## **Appendix E:      Requests for Information**

### Hope Bay Mining Project

Subject:	North Dam SRK Engineered Drawings	Project Zone/Area:	Hope Bay / Doris North
Company:	Nuna Logistics Ltd. (Nuna)	Station/Location:	Doris North - North Dam
Attention:	Kevin Mather/Doug Fielding cc. SRK Engineering	Discipline:	Civil

# ~ WHAT HAS BEEN FABRICATED ON SITE (AS OF APRIL 14, 2011)

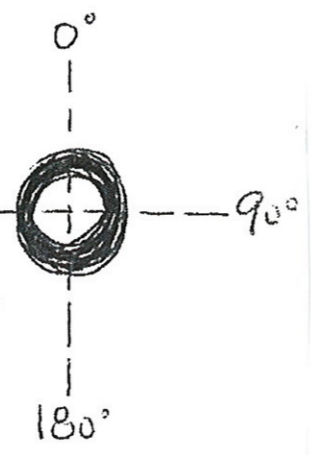
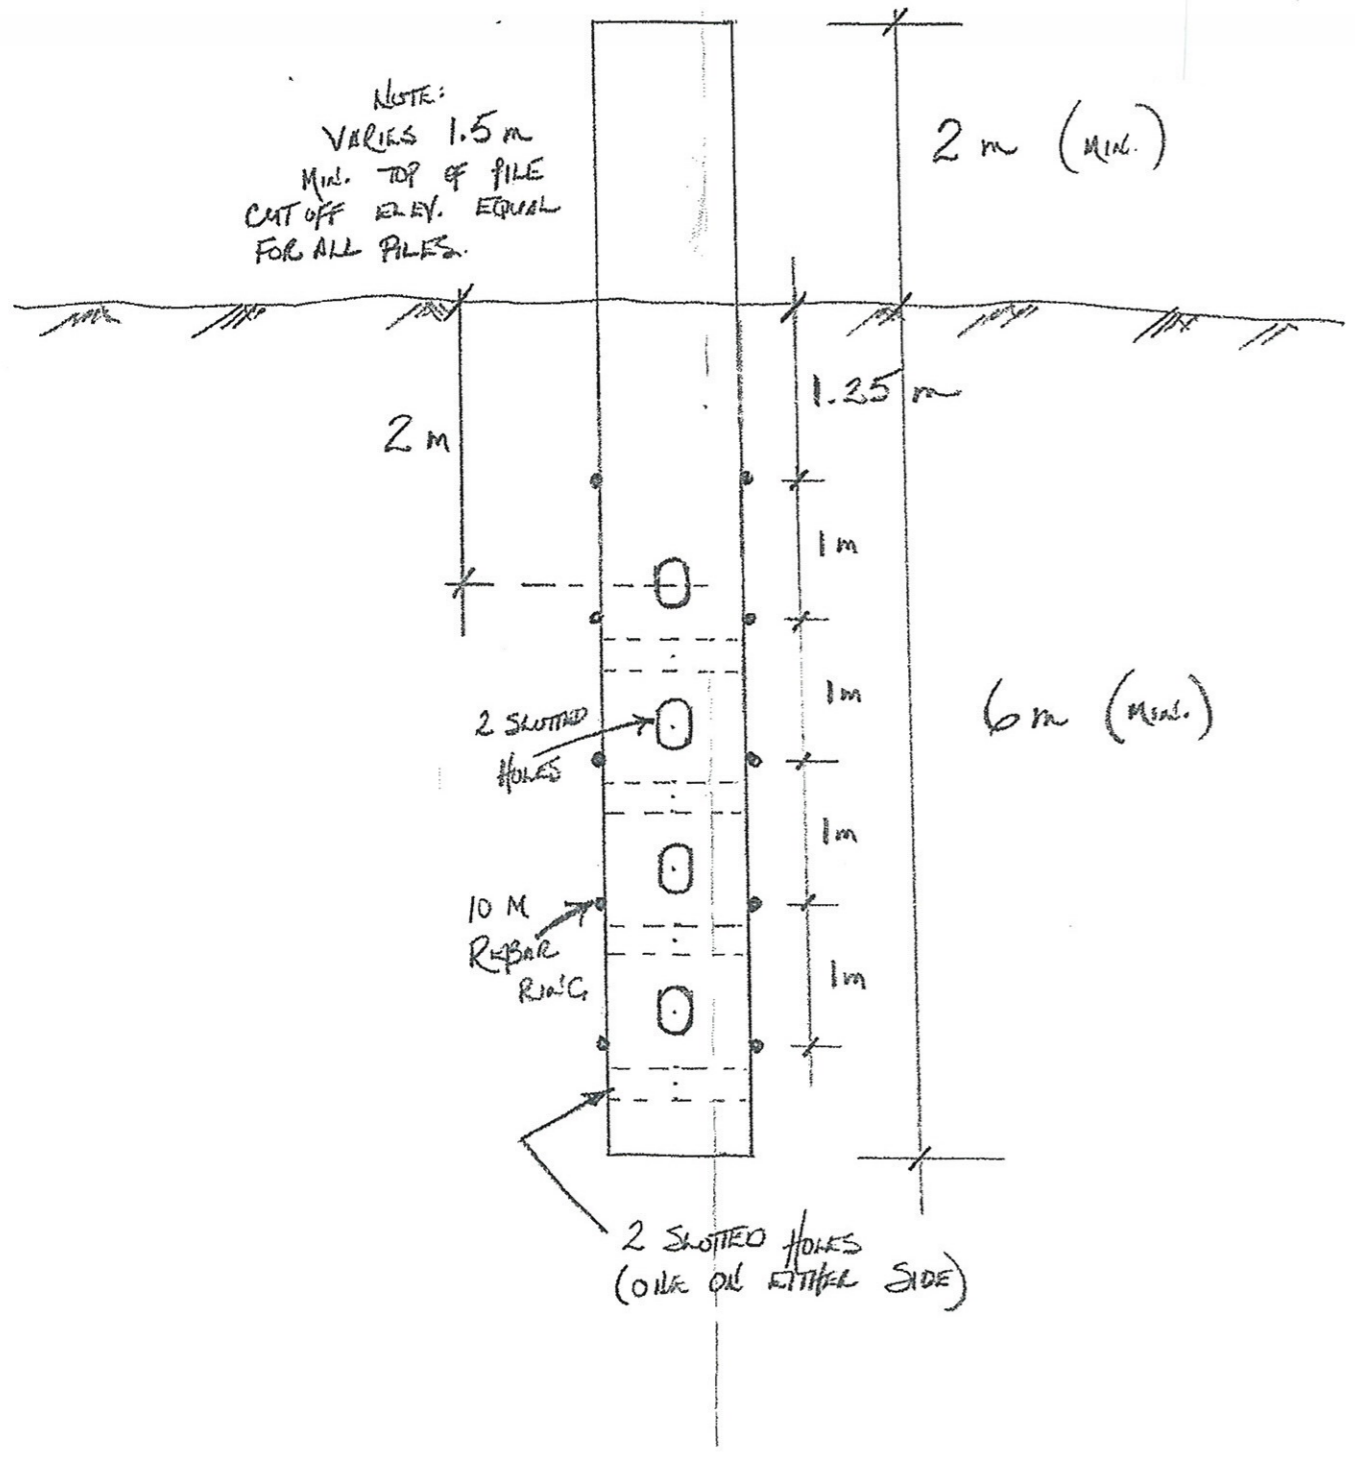
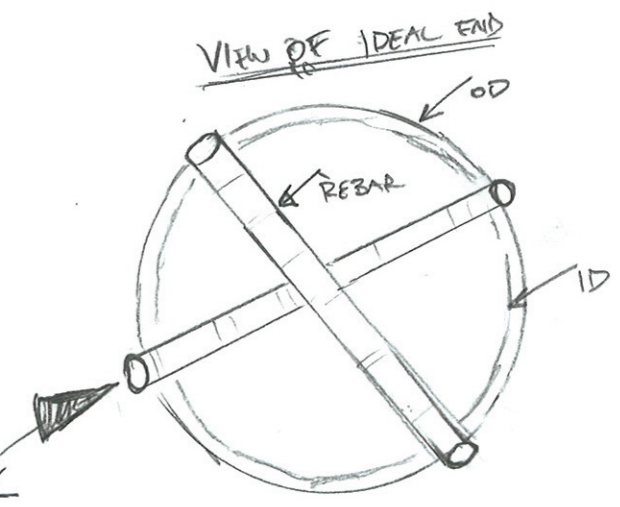
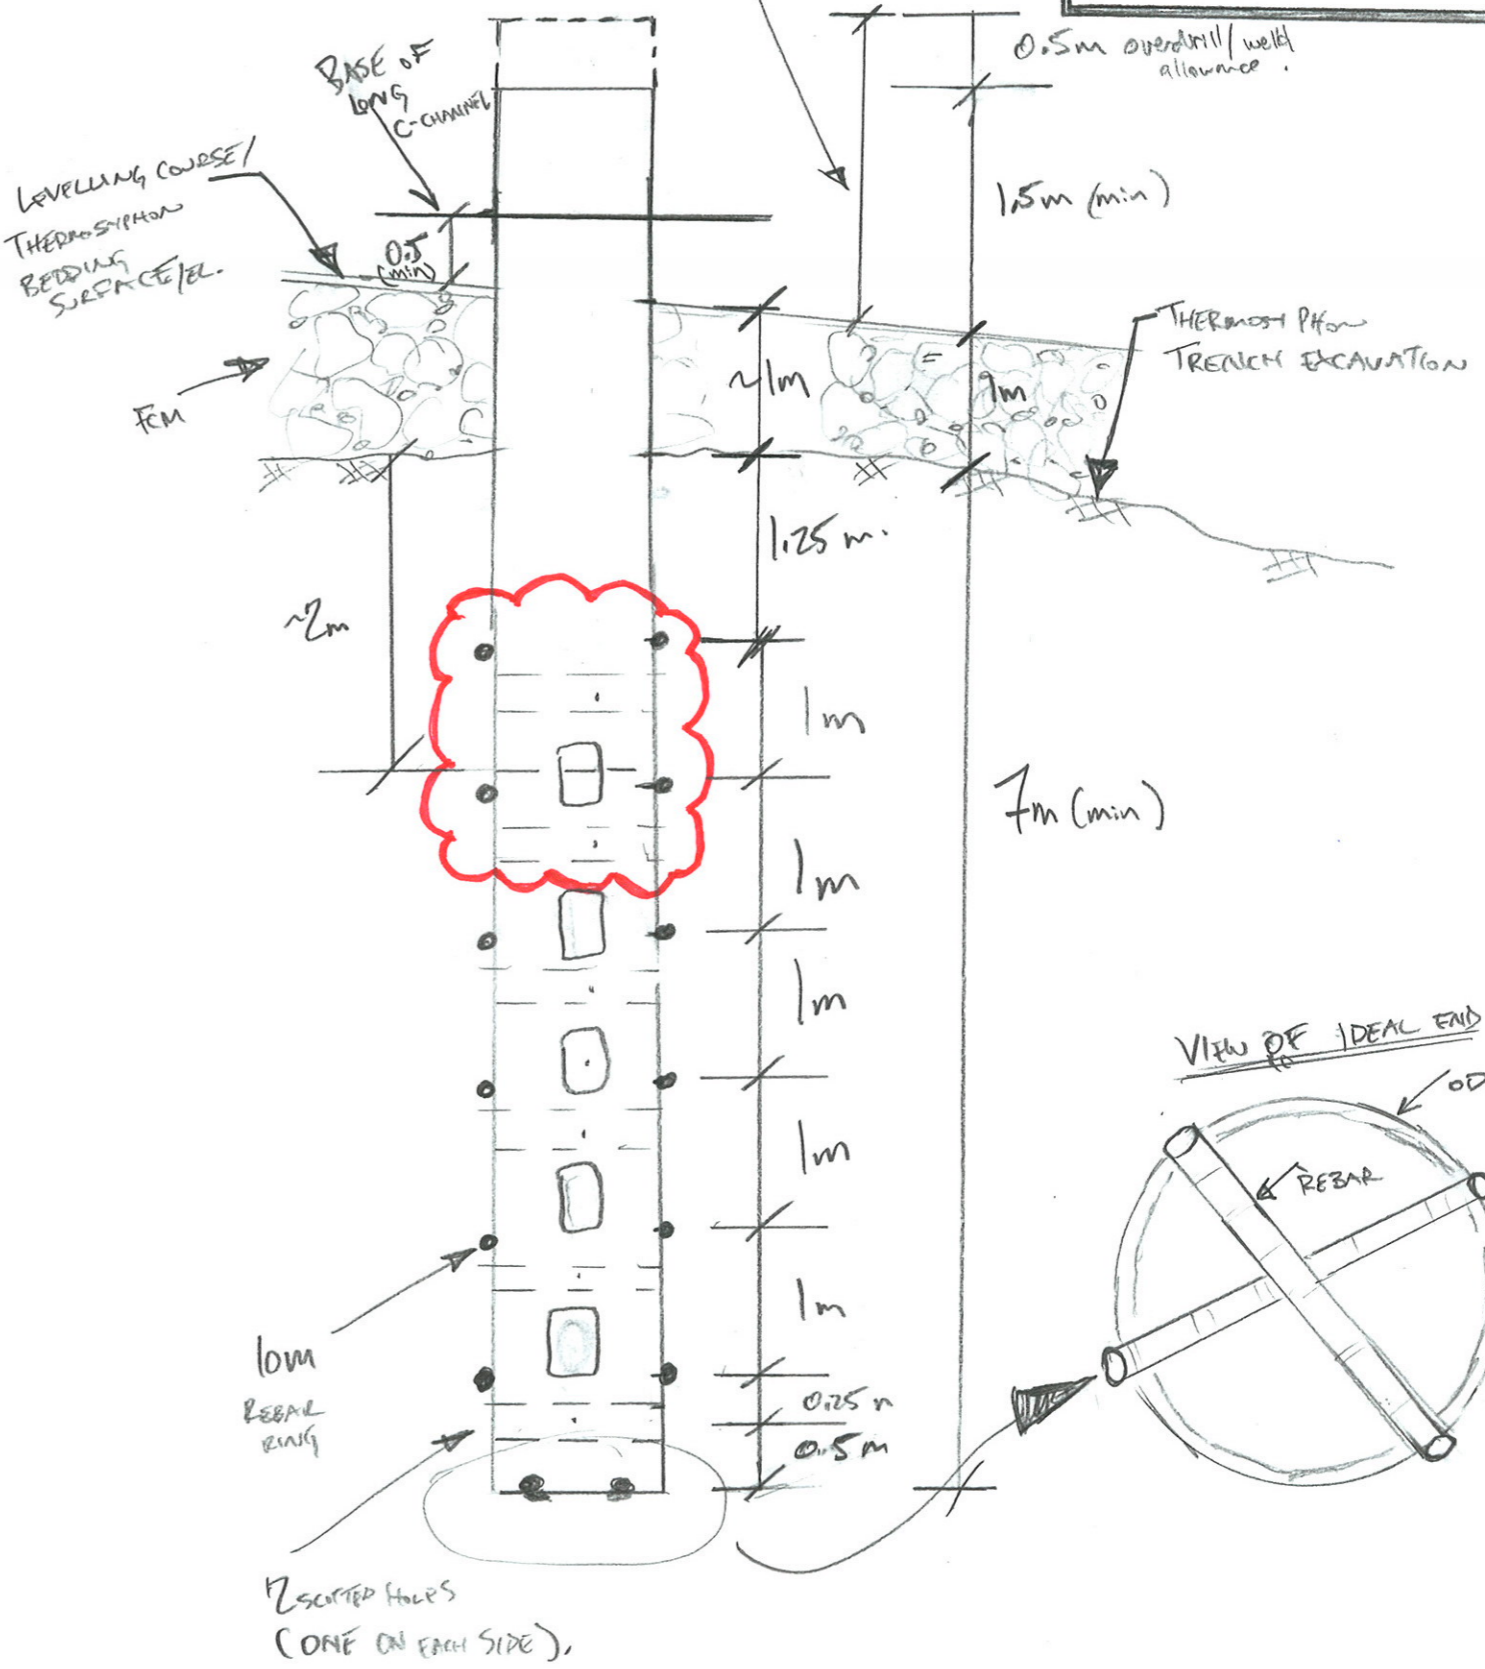
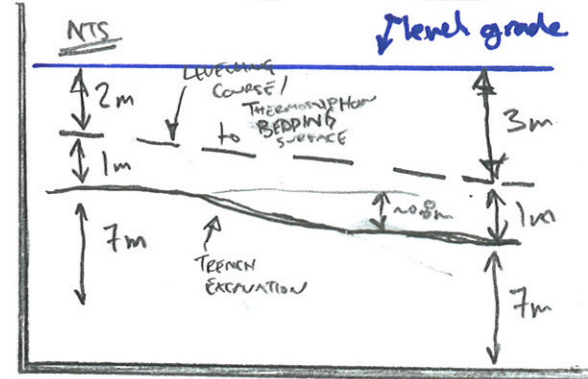
CENTRALIZERS/LUGS ON EACH PILE @:

- EQ. @ 1 m @ 45° ORIENTATION 270°
- @ 2 m @ 135° ~||~
- @ 3 m @ 225° ~||~
- @ 4 m @ 315° ~||~

NOTE:  
VARIES 1.5 m  
MIN. TOP OF PILE  
CUT OFF ELEV. EQUAL  
FOR ALL PILES.

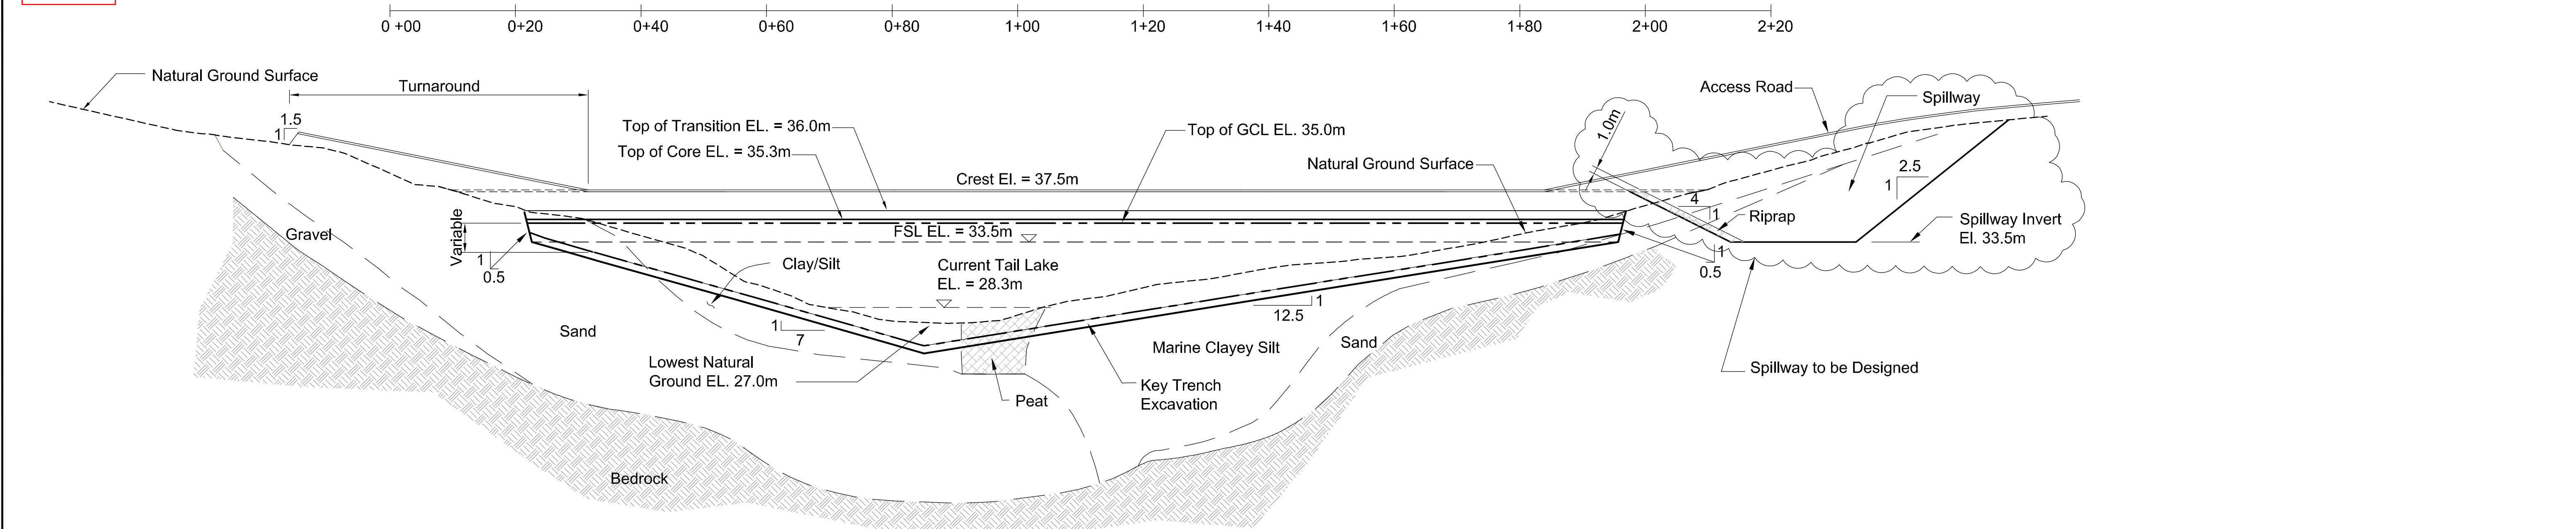
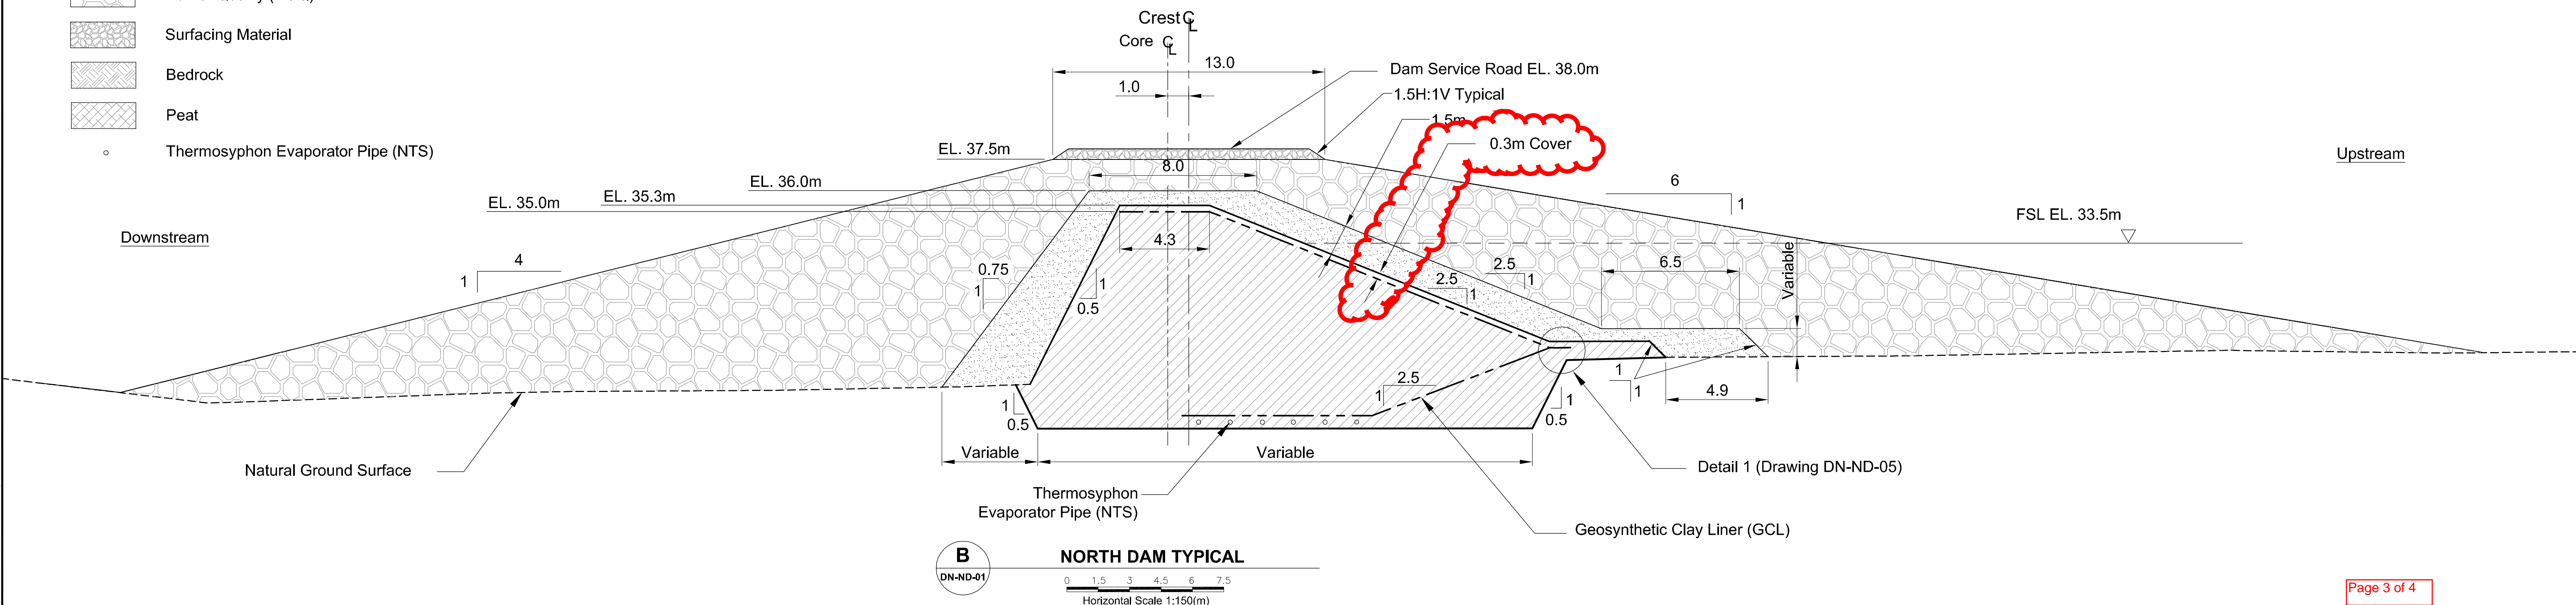
SRK Drawing No: DN-ND-02 (refer to attachment) shows 0.3 m of cover material placed above the upper panel of GCL. The cover material is illustrated as being "core material". The cover material refers to the material upstream and on top of the upper GCL placed on the upstream slope and over the crest of the frozen core material. Technical Specifications Revision "G" Section 5.2.7 Core Material, Table 5.4 (refer to attachment) provides the particle size distribution limits. Technical Specifications Revision "G" Section 6.4.3 GCL Cover (refer to attachment) outlines the parameters with placing cover material. Technical Specifications Revision "G" Section 6.4.3 GCL Cover specifies the material must be compacted to a maximum of 90% of the maximum dry density (ASTM D698) to prevent damage to the GCL.

3. The cover material shall comprise Core material as specified in Section 5.
4. Uncovered edges of GCL panels shall be protected with a waterproof sheet adequately secured with ballast, if the GCL installation sequence is delayed for a period in excess of 12 hours or the edges remain exposed for a period in excess of 12 hours.

8. The first fill of Cover material over the GCL shall be compacted to a maximum of 90% of the maximum dry density (ASTM D698) or as specified by the Engineer to prevent damage to the GCL. Subsequent lifts, if required, of the Cover material over the GCL shall be compacted to 95% of the maximum dry density (ASTM D698). Moisture conditioning may be required to achieve the specified level of compaction.

9. The cover material should be pushed up-slope to minimize tension on the GCL when covering GCL on sloped areas.
10. Precautions shall be taken to prevent damage to the GCL by restricting the use of heavy equipment over the GCL.

Subject **N. DAM CONSTRUCTION - GCL Tie-in Discussions** Sheet **1** of **1**

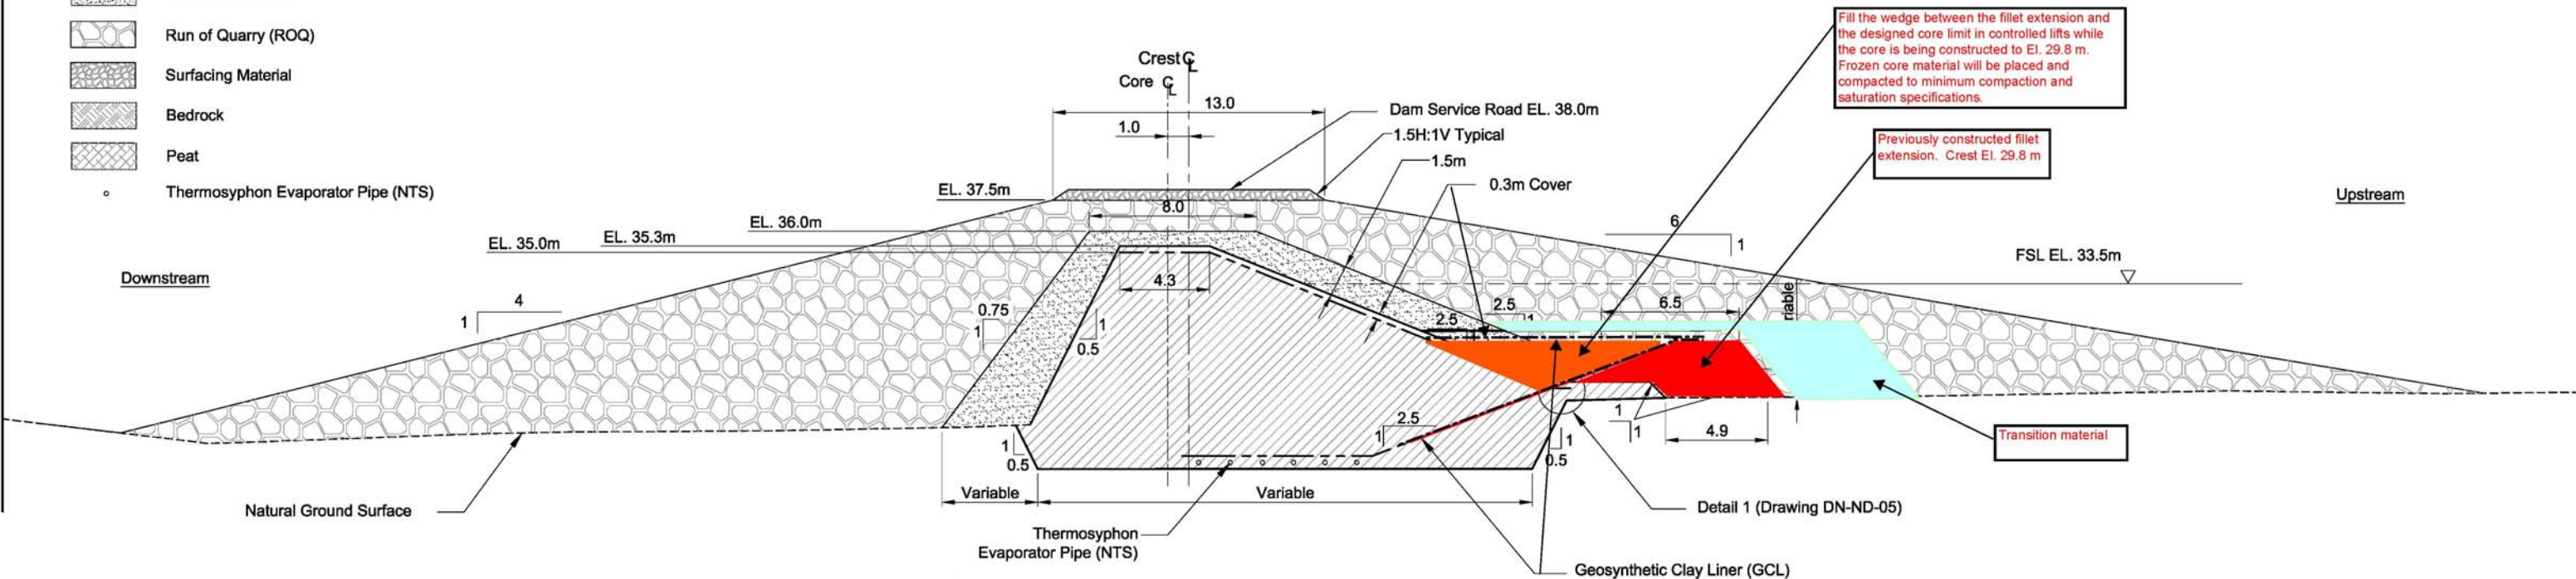
It is our intent to construct the frozen core to El. 29.8 m in controlled lifts that meets the compaction and saturation criteria. This construction methodology will fill the wedge between the design core lines along the upstream side of the core superstructure and the previously constructed fillet extension between Sta. 0+70 and Sta. 1+20. The upper GCL panels will overlap the lower GCL panels by the required 1.0 m on the horizontal plane of the fillet extension at El. 29.8 m. The upper GCL panels will extend on the horizontal plane at El. 29.8 m to the point where they meet the 2.5H:1V upstream slope of the frozen core where they will then continue as per the IFC drawings. The minimum GCL cover (0.3 m) dimension and subsequent minimum cover of transition material will be maintained.

The proposal to place additional FCM in the fillet expansion area to El. 29.8 m in controlled lifts that meet saturation, compaction and freezeback criteria is acceptable to SRK. Based on recent conversations (see SRK daily #18 and 27) and volume assessment it is noted that filling in this wedge between the IFC core design lines and the 2011 fillet extension will provide constructability and liner installation related benefits. A 1m overlap for the upper and lower GCL liner layers is acceptable. The quality of the lower GCL liner and the required extent of liner repairs on the fillet will be assessed in the field, after the liner is exposed. The minimum cover of core material over the GCL and subsequent minimum cover of transition fill, as noted above, should meet the design intent of the IFC's. For reference additional notes are presented on the attached figures.

This assessment has now been completed. As outlined in this RFI the preferred option will be to fill in the wedge that would remain between the 2011 fillet zone construction and the IFC design core limits (i.e. this area will be slightly overbuilt)
